Belmont Quarry Development – Part A

Substantive Application
Appendix A.4.1 – Section 29 Consultation Summary
Report Appendix A - C
Winstone Aggregates

16 August 2026

Figure 1: Figure 2.1 from the hydrological assessment, showing the catchment drainage patterns

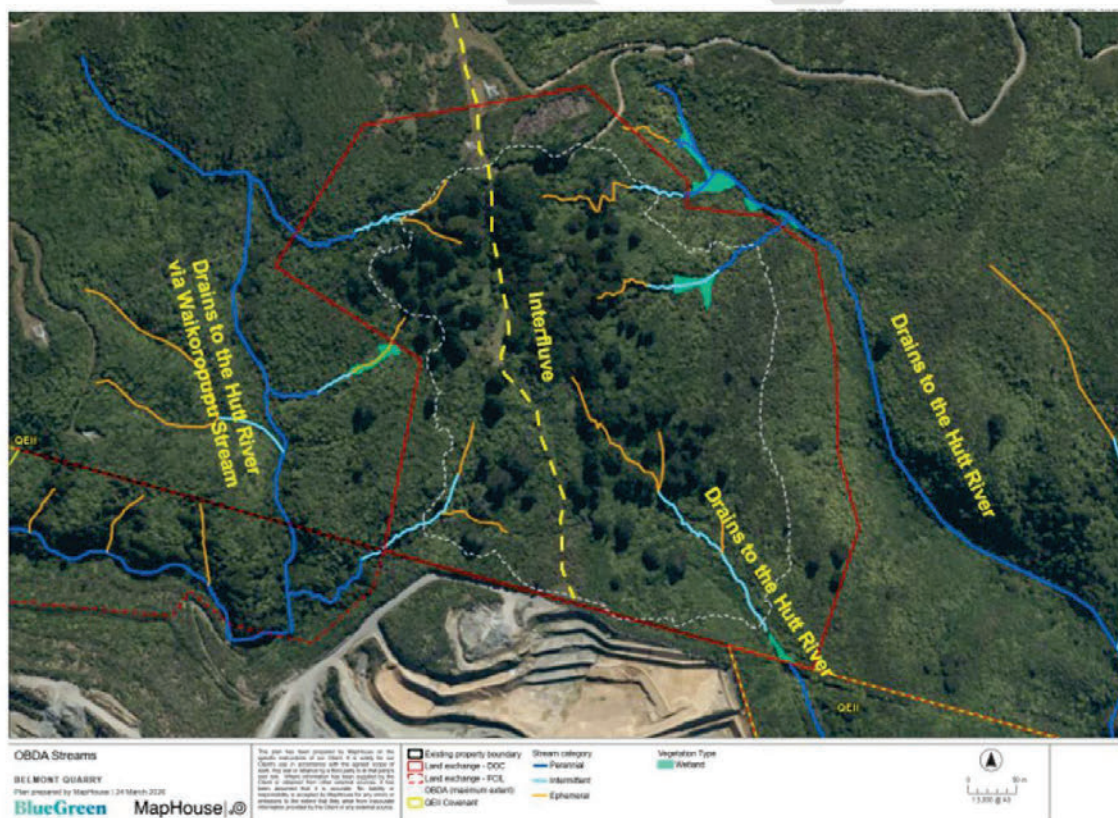
Figure 1 shows the catchments with notation is to where the streams drain to, and Figure 2 shows the location of the SEVs.

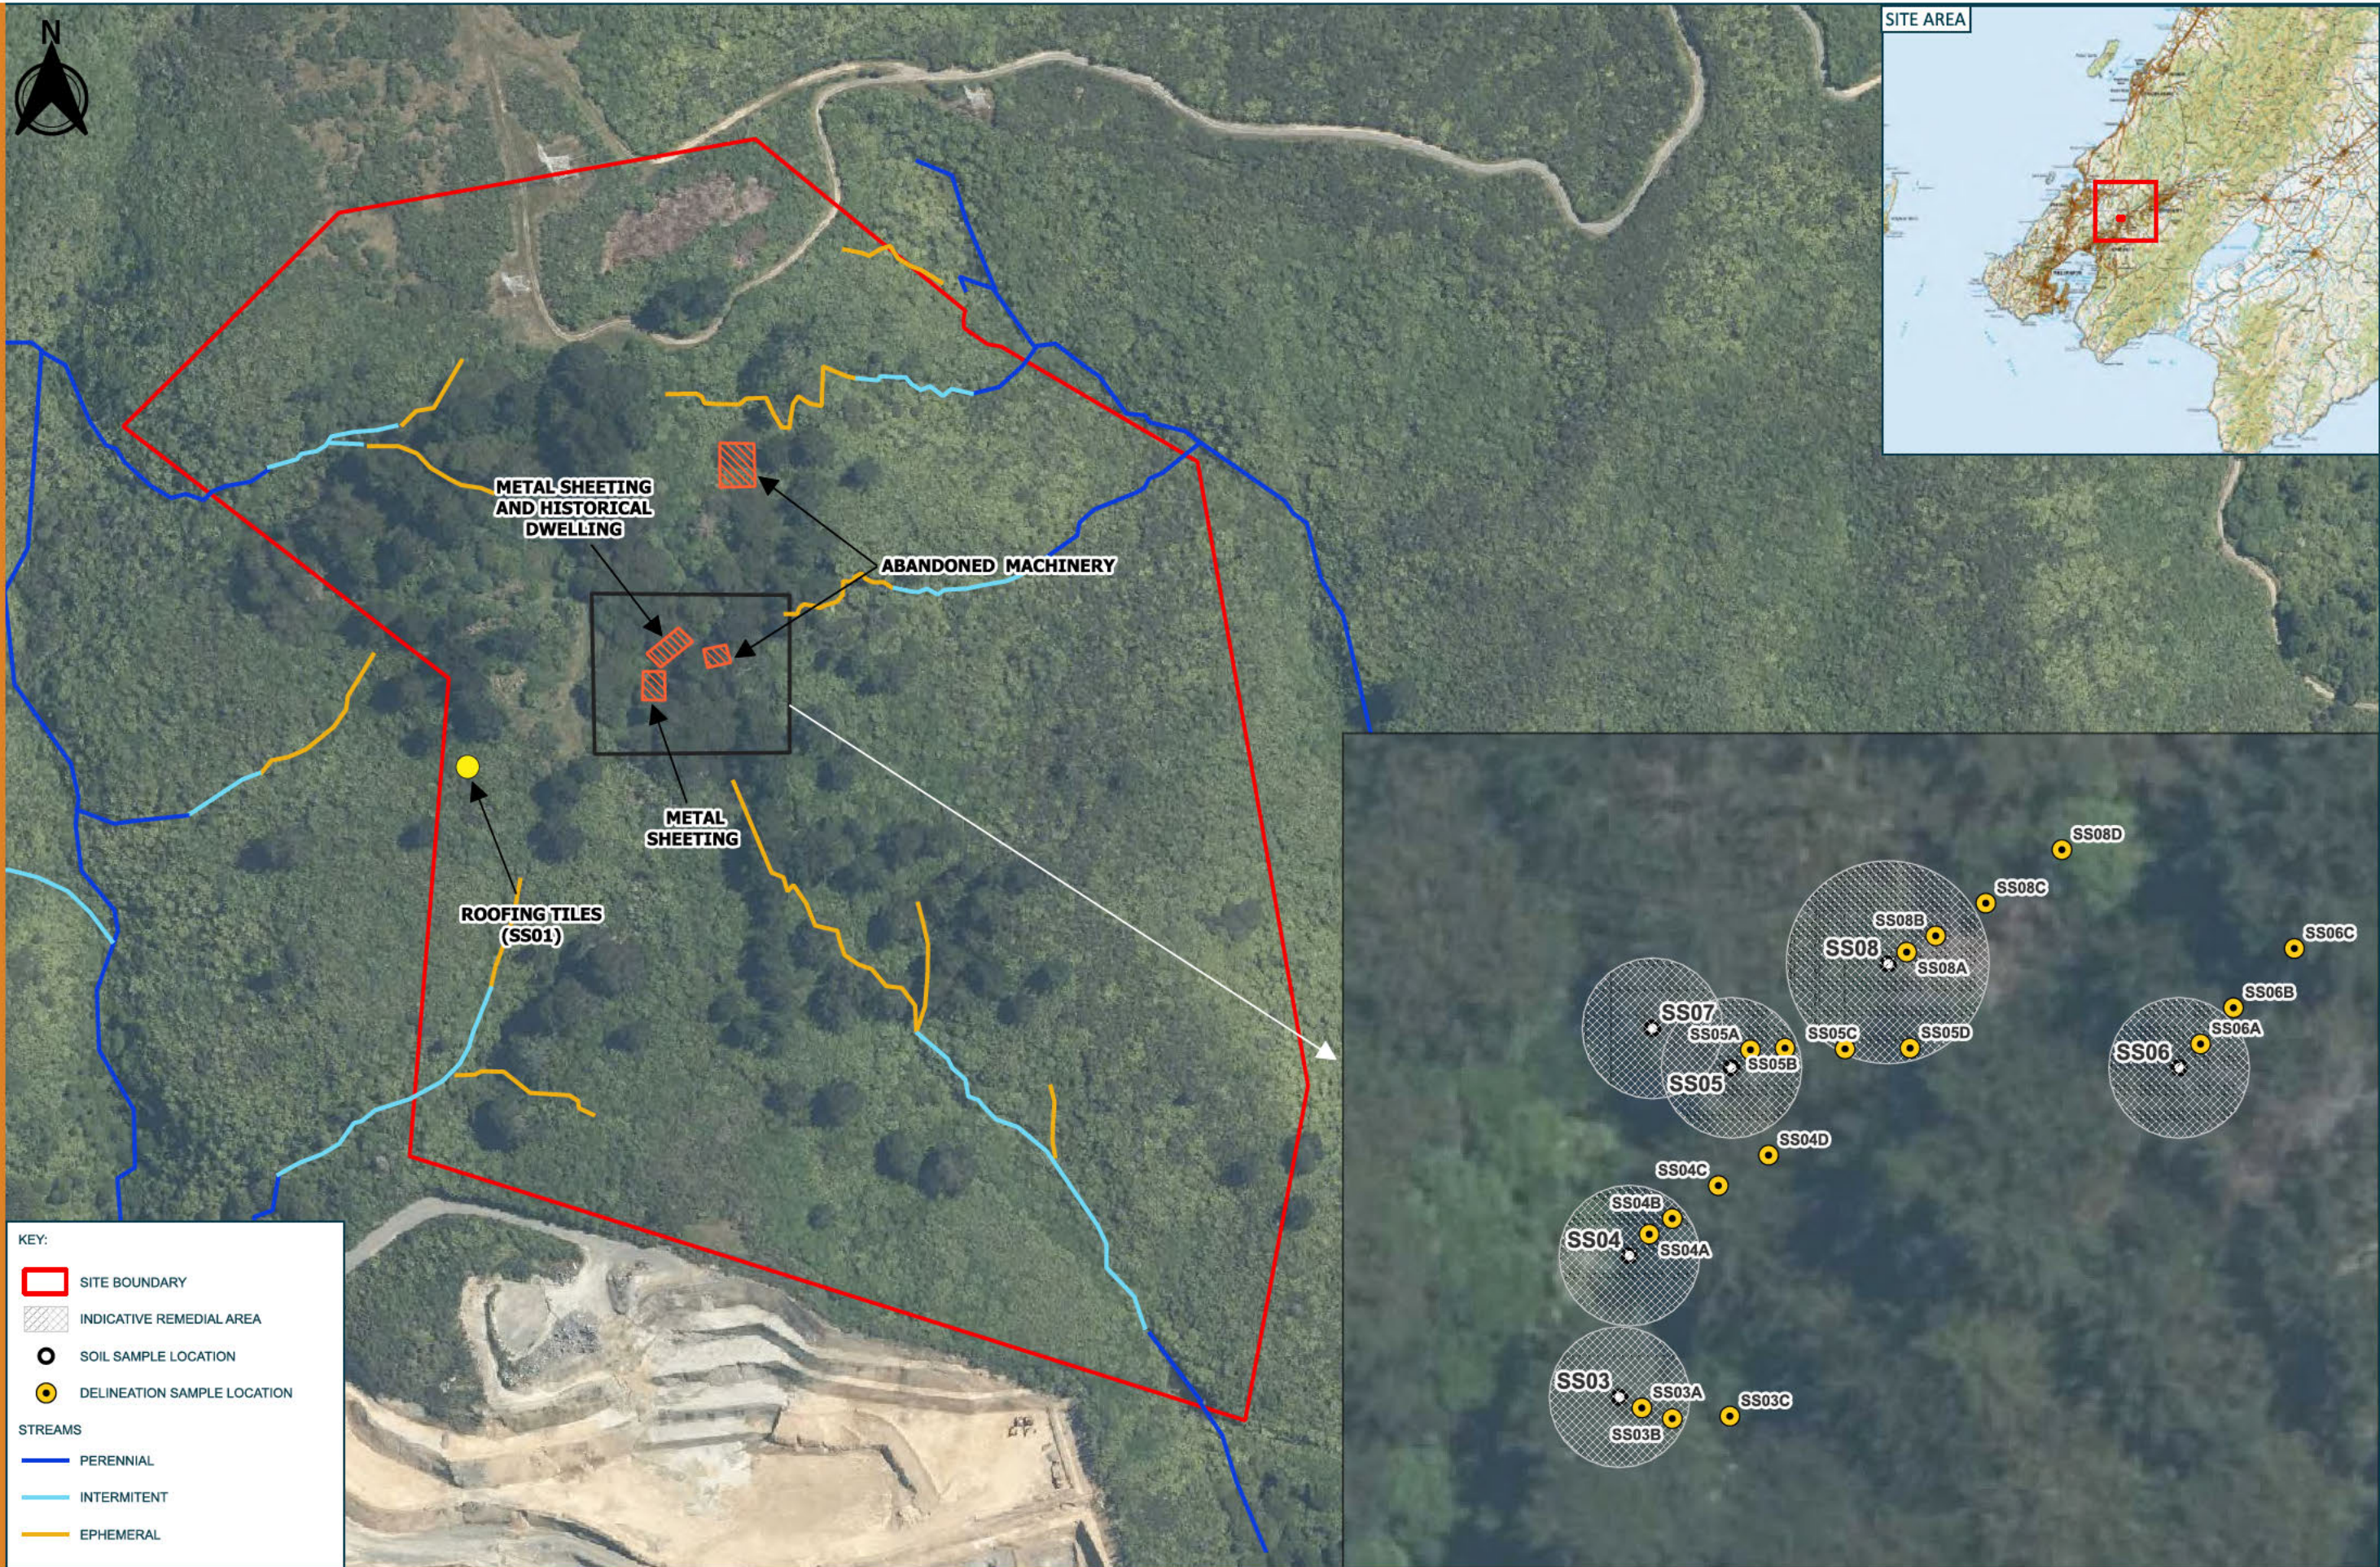
Other than noting “any other waste, metal/machinery identified during site redevelopment”; the RAP is essentially silent on the second piece of abandoned machinery that was not sampled as part of the DSI. Figure 1 does not show this as being an indicative remedial area. It is recommended that the

RAP is updated so that it is clear that this second piece of abandoned machinery will be sampled and remediated (if required) as part of remediation works.

Figure 1: Savage Park EWS Windrose (January 2022 to December 2025)

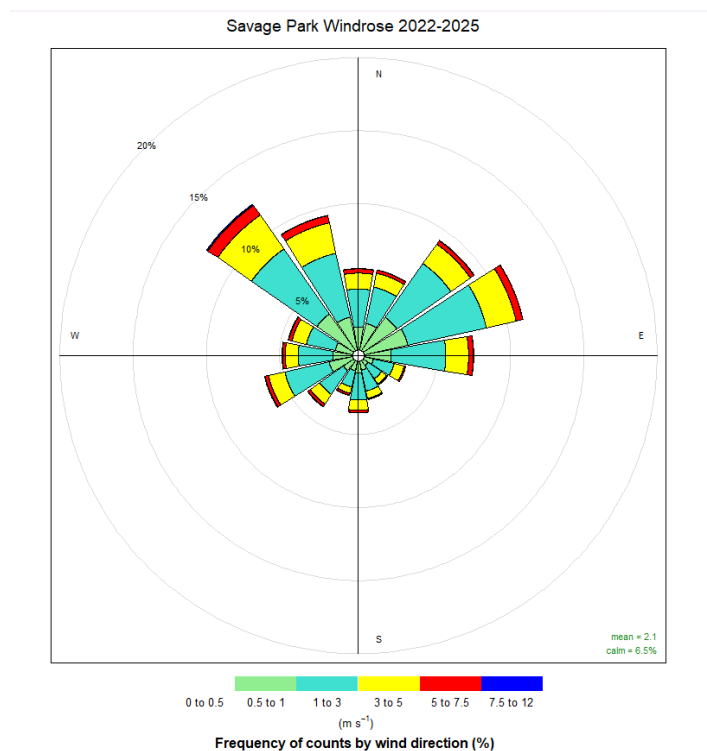
Figure 1 shows wind conditions observed at the Savage Park EWS for the four year period 2022 to 2025. This data shows similar patterns to those presented in the shorter term windrose used in the AQA (prevailing wind still comes from the northwest) with more variation and frequency in winds from the south. The similarities between this 2022-2025 windrose and the shorter term windrose in the AQA means that the FIDOL assessment would not significantly change if the updated windrose was used in its place.

Therefore, PDP considers that the existing FIDOL assessment in the AQA is adequate for assessing dust nuisance and does not need to be updated.

Figure 2: Staging of OBDA and Vegetation Removal

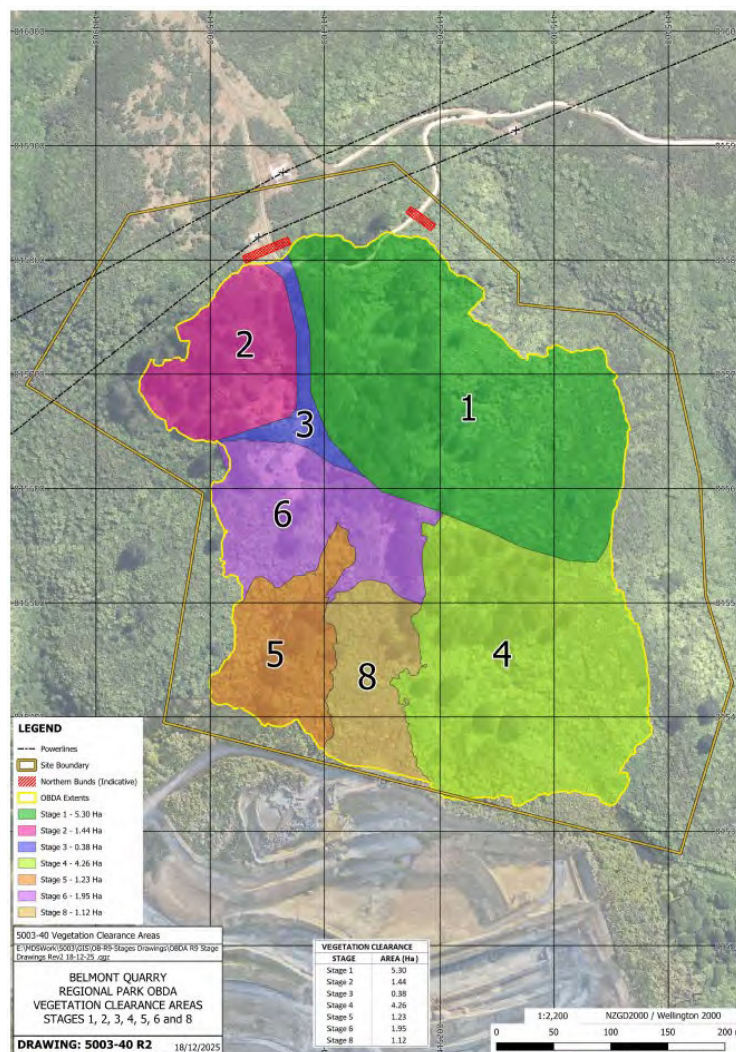
Figure 3 provides details of the total area that each stage will cover when finalised. While Stage 1 covers an area of 5.3 ha, each corresponding stage covers an area of less than 2 ha with the exception of Stage 4 (4.26 ha total). Furthermore, Winstone has confirmed that Stage 1 (and following stages) will be progressively cleared, which means that at no stage will the active OBDA be greater than 5 ha, and generally it will be less than 2 ha. In addition to this, all of the mitigation measures discussed in Section 5.0 of the AQA will still be used to minimise generated dust emissions, with progressive rehabilitation used where practical to control the potential for windblown dust.

Consequently, the size of the open areas will be comparable to that consented elsewhere.

Figure 3: Difference in Particle Travel with wind speed

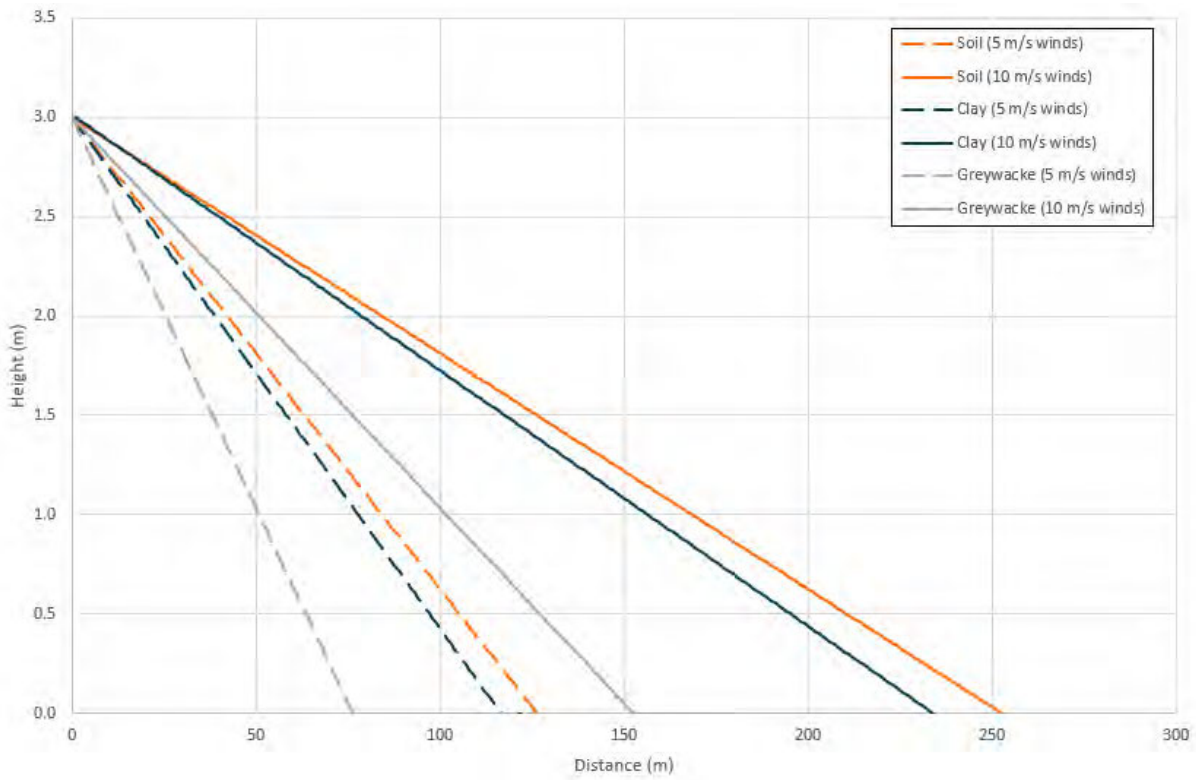
2.5.2 *Figure 7 includes information for concrete particles, which are not relevant to this project. It is recommended that this figure be updated to include more representative of overburden materials, such as weathered greywacke and associated fine soils (e.g. silts and clays), or sands.*

Figure 7 in the AQA contained information that should have been updated. Therefore, PDP has provided an updated estimate of travel distances in Figure 3. These have been calculated using Stokes Law with the following assumptions:

This updated figure shows that the other material considered does not travel further than the soil particles and does not change the AQA conclusions of Section 7.1.

Figure 6: Polar Plot of Hourly Mean of TSP During Season Six

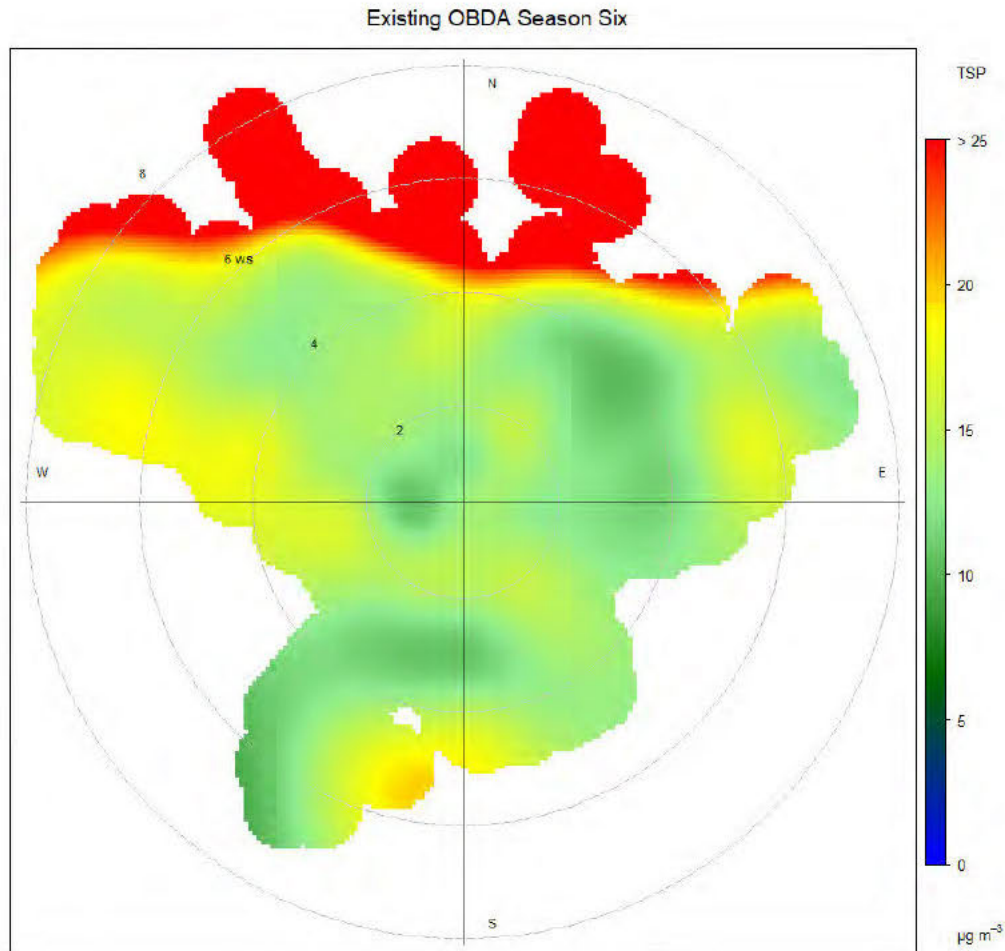
For completeness we have provided a summary of the Season Six TSP concentrations, and a polar plot in Table 2 and Figure 6 respectively. Figure 6 shows the hourly mean TSP concentrations recorded during Season Six using the same scaling as the Season Seven polar plot in the report. In addition to this Table 2 shows the TSP concentrations observed in Season Six are not significantly different at the median or 75%ile values, with the only difference being the maximum values. The use of these values instead of

those from Season Seven would not make a significant difference to the analysis and conclusions of Section 7.2 of the AQA, or require the use of additional mitigation measures.
